C-E Power Systems
Combustion Engineering, Inc.
1000 Prospect Hill Road
Windsor, Connecticut 06095

December 5, 1984
LD-84-069

Subject: CESSAR Consistency Review Changes

CESSAR INTERFACE REQUIREMENTS AND
SEQUENCE OF EVENTS CHANGES
TO CLARIFY RESPONSE TIMES

SEQUENCE OF EVENTS DIAGRAM FOR LOC V

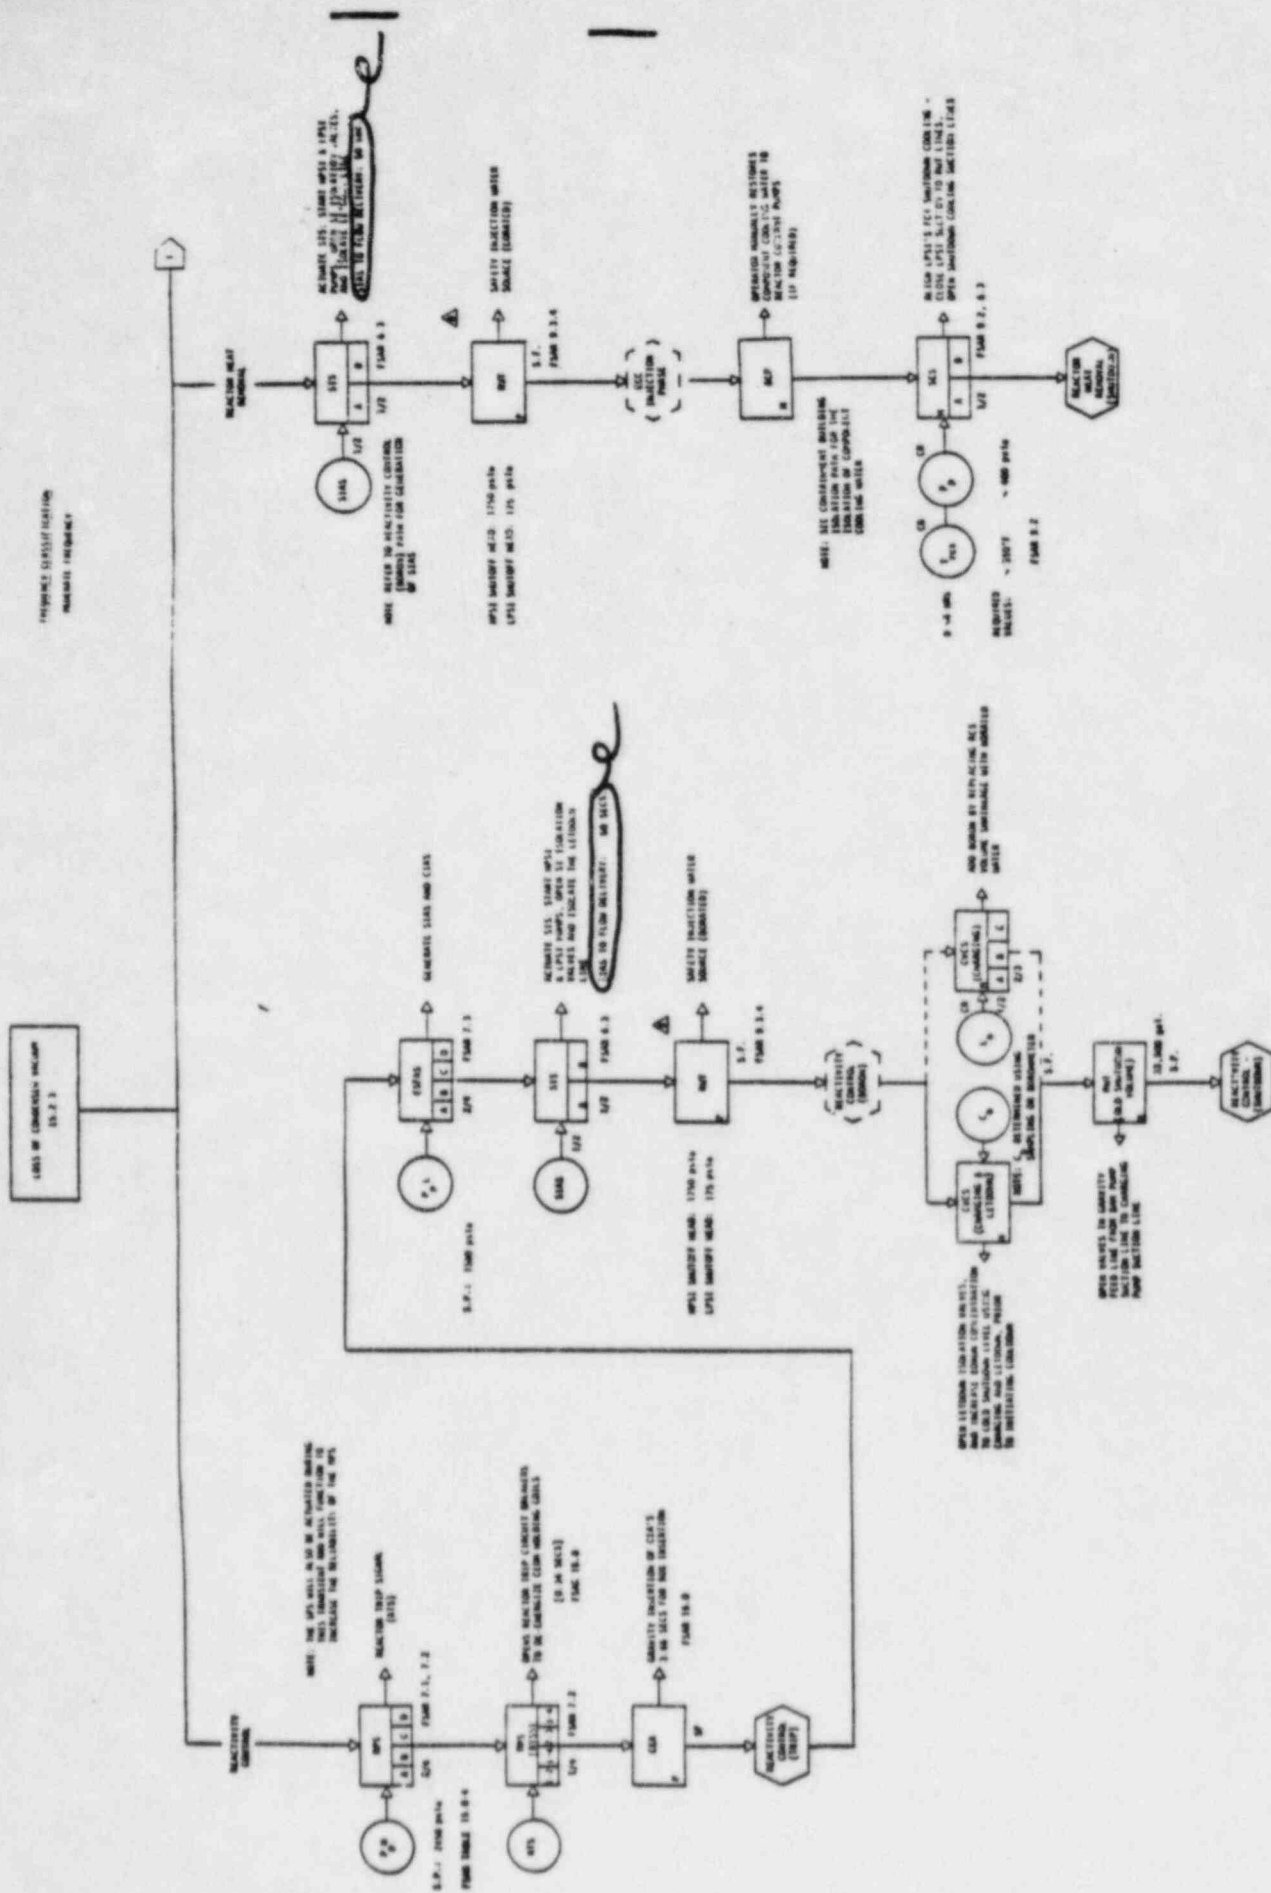
TABLE 15.2.2-1 (Cont'd)
SEQUENCE OF EVENTS FOR THE LOCV

<u>Time (Sec)</u>	<u>Event</u>	<u>Setpoint or Value</u>	<u>Success Path</u>
1150.0	Borated HPSI Flow Enters the Core		Reactivity Control
1408.0	EFAS Withdrawn, percent of wide range	80	Secondary System Integrity
1800.0	Operator Initiates Plant Cooldown		Reactor Heat Removal

Steam Generator Water Level
 Reaches EFAS Reset Analysis
 Setpoint, percent of wide range

SEQUENCE OF EVENTS DIAGRAM FOR
TOTAL LOSS OF REACTOR COOLANT FLOW

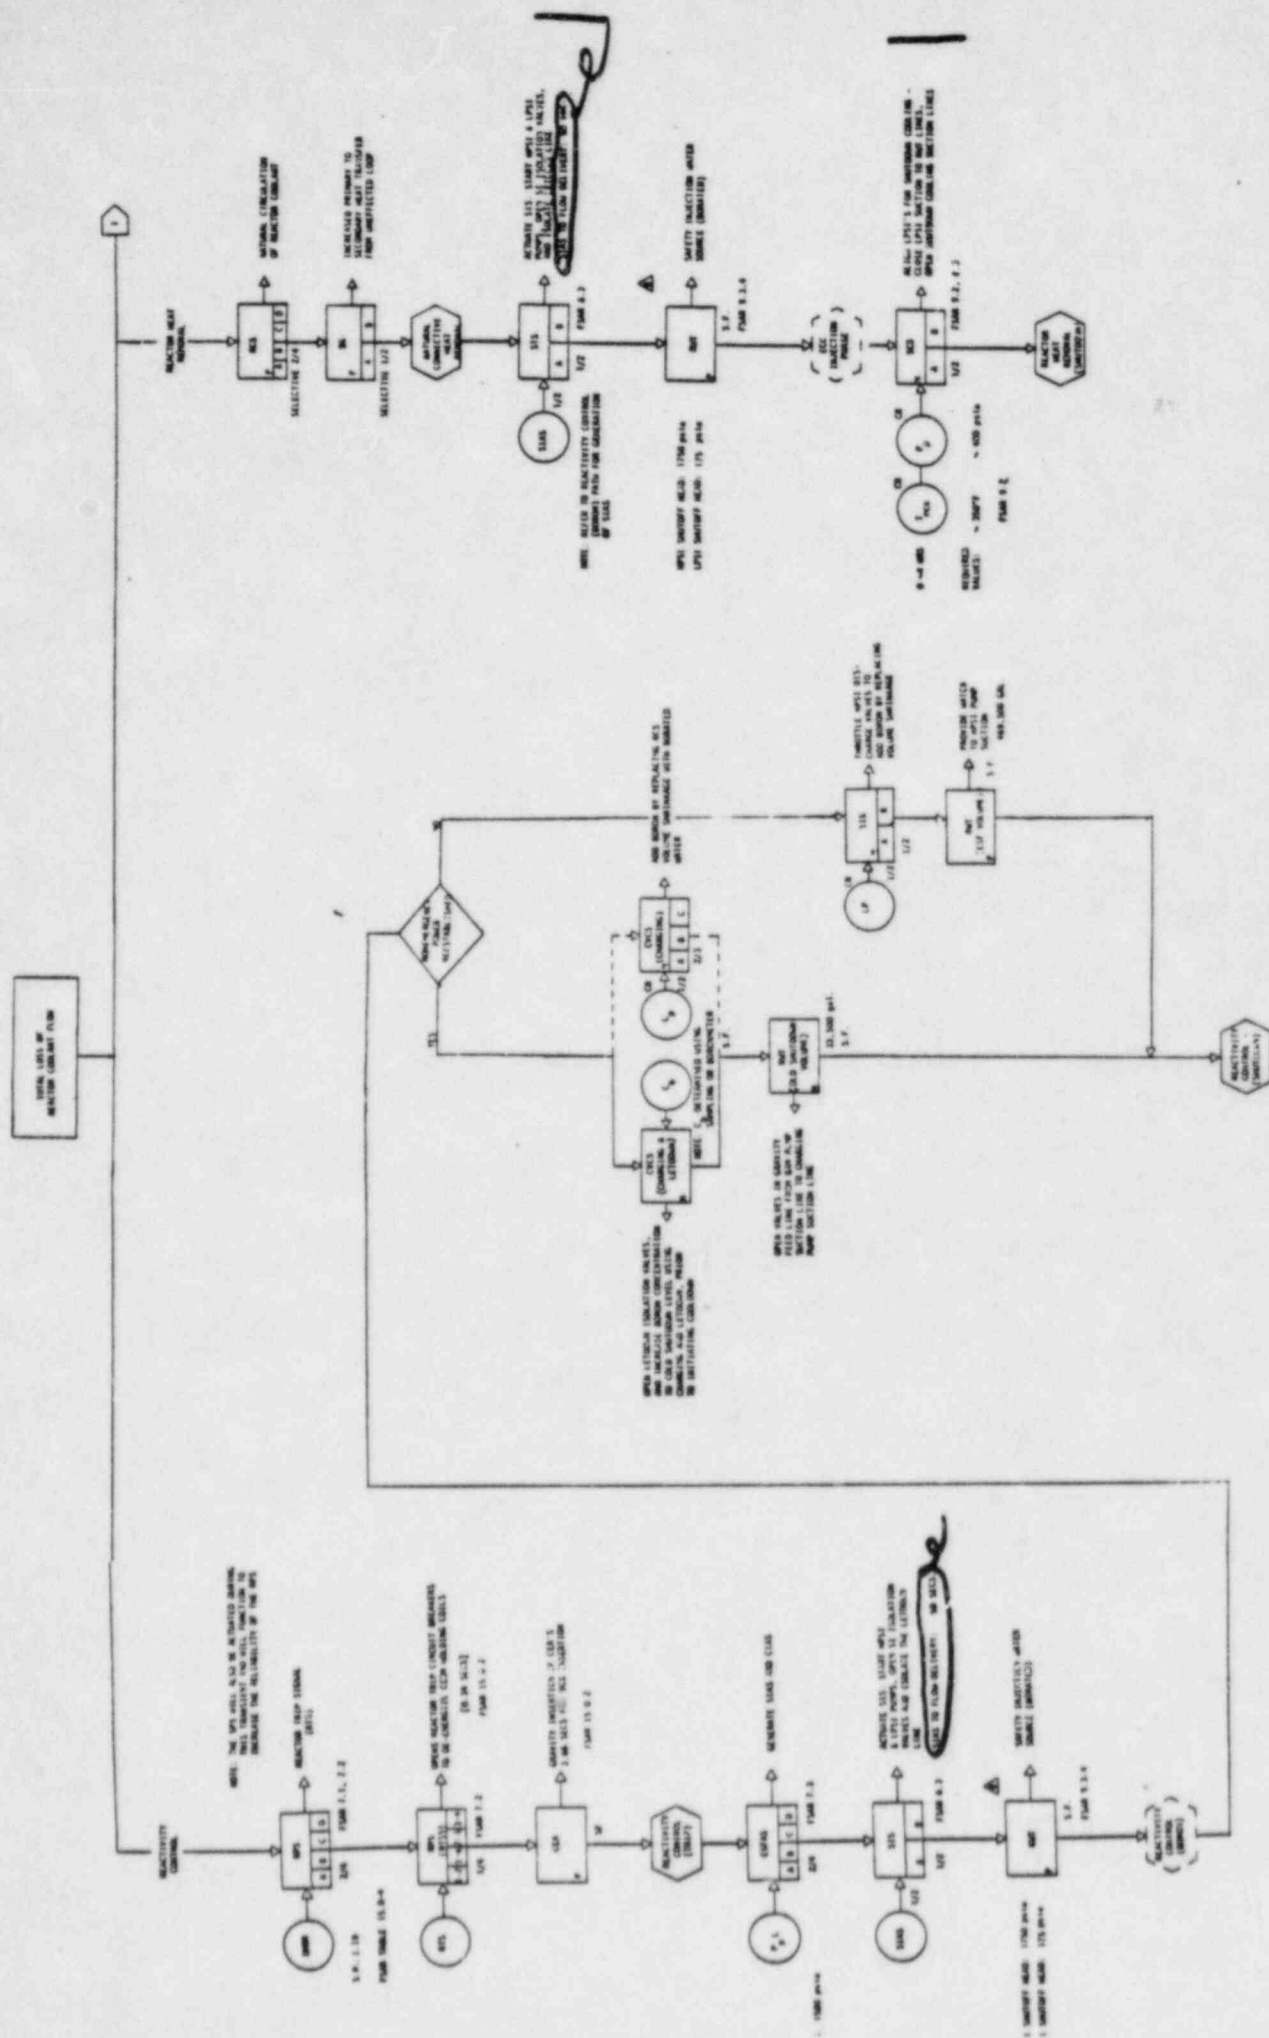
SEQUENCE OF EVENTS FOR TOTAL LOSS OF REACTOR COOLANT FLOW

<u>Time (Sec)</u>	<u>Event</u>	<u>Setpoint Or Value</u>	<u>Success Path</u>
0.0	Loss of Offsite Power - Turbine Trip - Diesel Generator Starting Signal - Reactor Coolant Pumps Coast Down - Main Feedwater Is Lost		
	<i>Loss of Main Feedwater</i>		
0.6	Low DNBR Trip Signal Generated, <i>Projected DNBR</i>	1.19 <i>Projected</i>	Reactivity Control
0.75	<i>Trip Breakers Open</i>		<i>Reactivity Control</i>
1.09	CEA's Begin to Drop		Reactivity Control
2.6	Minimum Transient DNBR	1.19	
4.3	Pressurizer Safety Valves Open, psia	2525	Primary System Integrity
5.3	Maximum RCS Pressure, psia	2576	
5.4	Main Steam Generator Safety Valves Open, psia	1282	Secondary System Integrity
11.7	Maximum Steam Generator Pressure, psia	1338	
12.2	Pressurizer Safety Valves Closed, psia	2463	Primary System Integrity
1800.0	Operator Initiates Plant Cooldown

SEQUENCE OF EVENTS DIAGRAM
FOR CEA EJECTION
WITH LOSS OF OFFSITE POWER

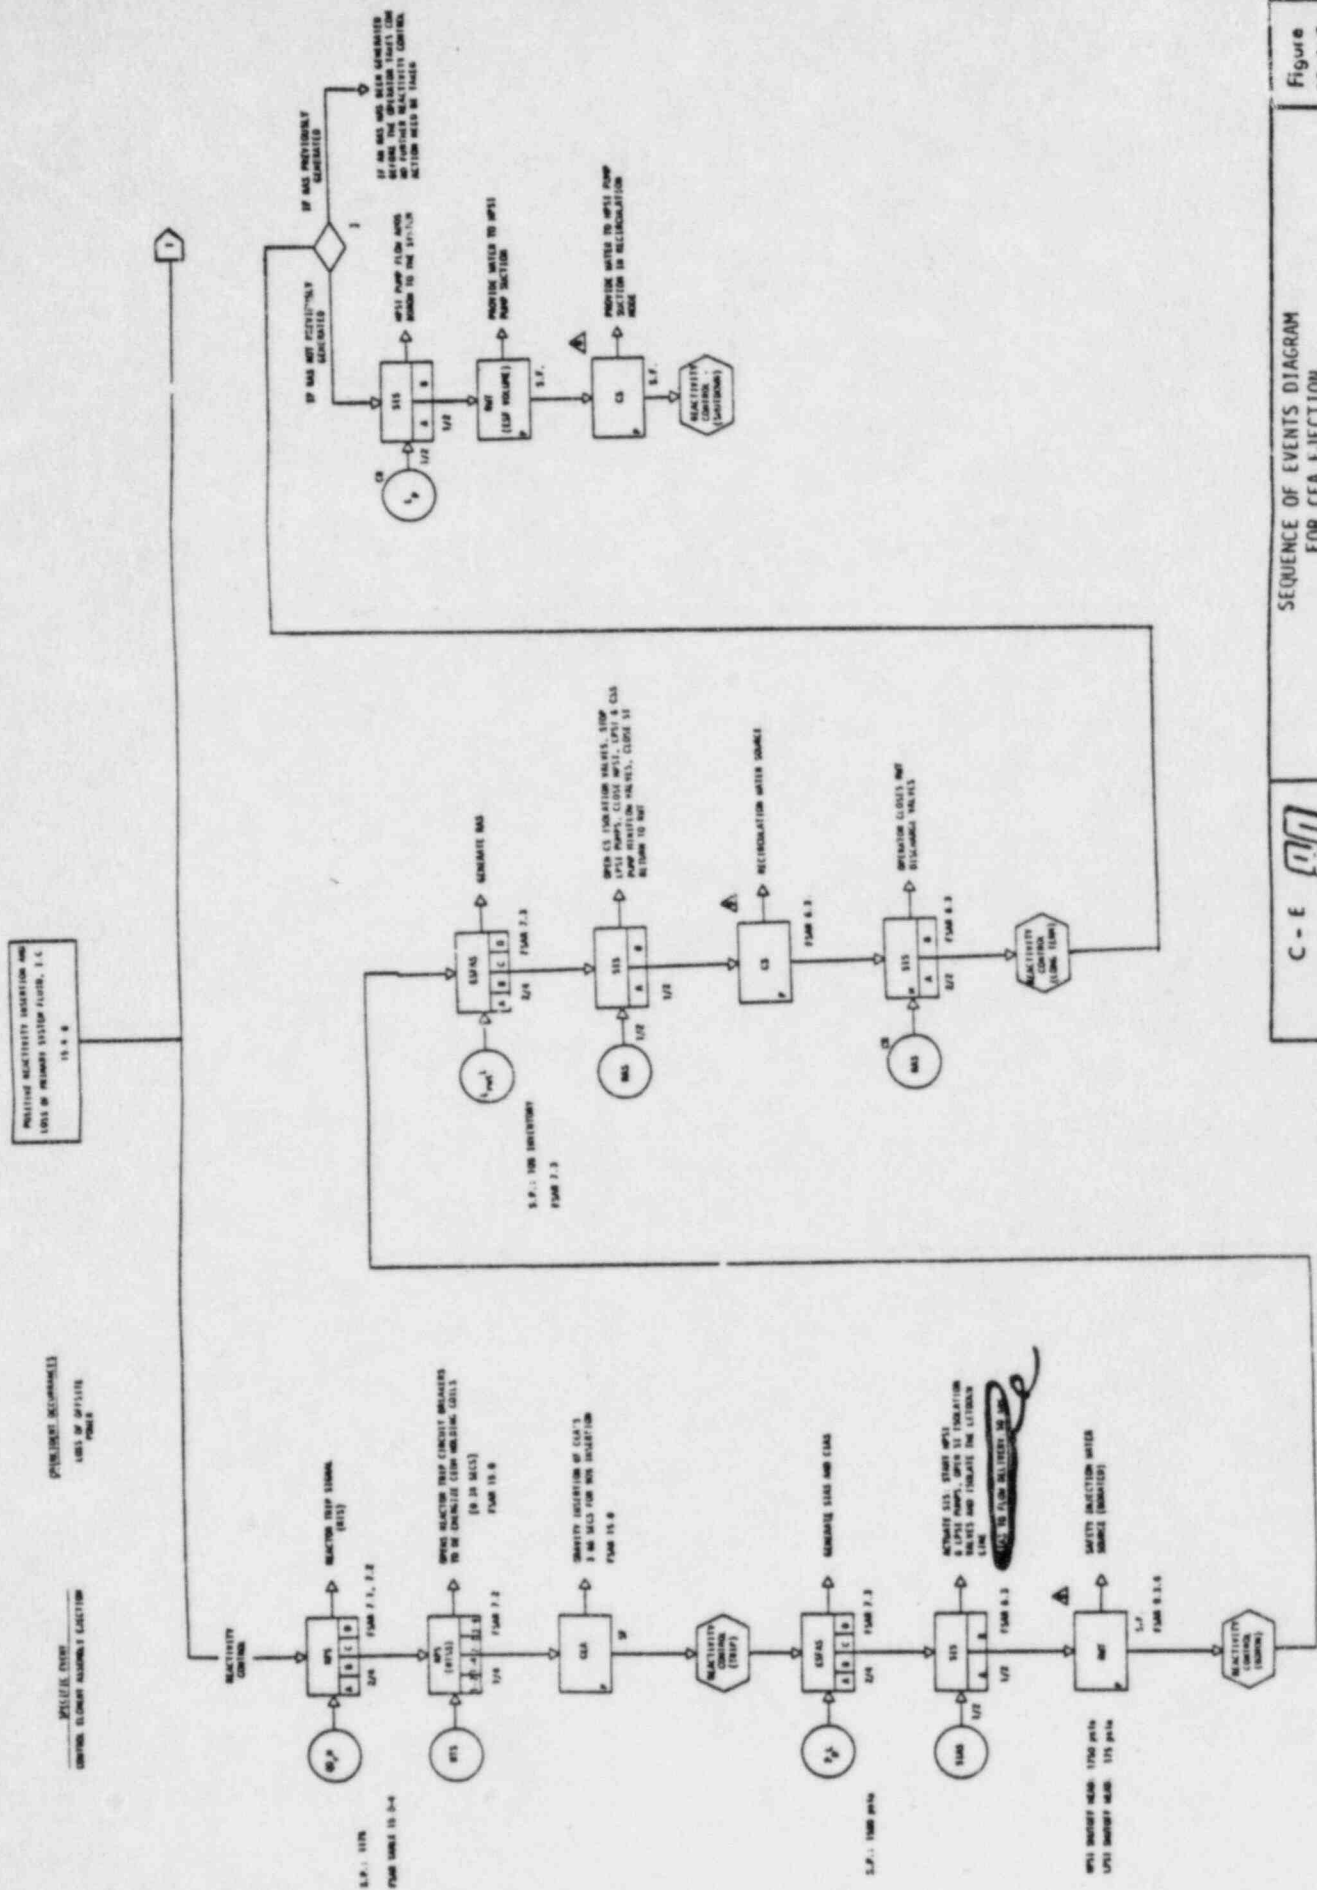
"B"

70.1	Safety Injection Flow Initiated	--	Reactor Heat Removal
------	------------------------------------	----	----------------------------
